SERVICE NEWS

No. FSN 4

**SUBJECT: FRANKLIN AIRCRAFT ENGINE CYLINDER RECONDITIONING MODELS
6A4-150, 6A4-165, 6V4-178 AND 6A8-215**

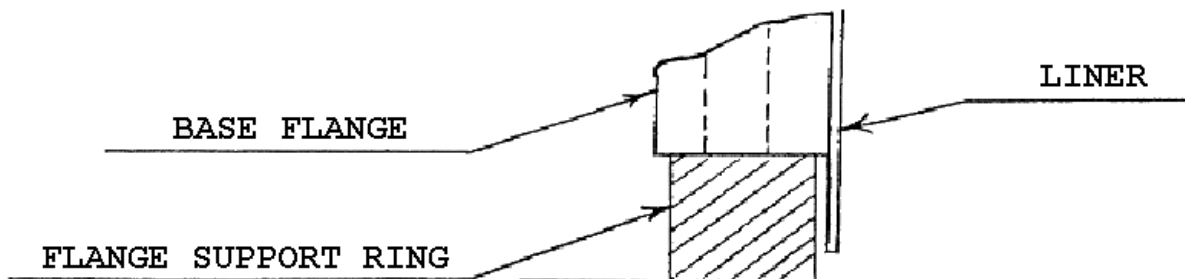
We have received reports to the effect that cylinders covering the above model engines are not being properly supported in some cases when valve guides are installed in the field as replacement due to removal of worn guides.

When valve guides are installed, after heating the cylinder in accordance with instructions in the Service Manuals, the cylinders should be supported on the base flange section and not on the cast iron cylinder liner.

Supporting the cylinder base flange on a steel ring thick enough to prevent the liner from taking any load will prevent the liner from moving up into the cylinder. See Sketch Below.
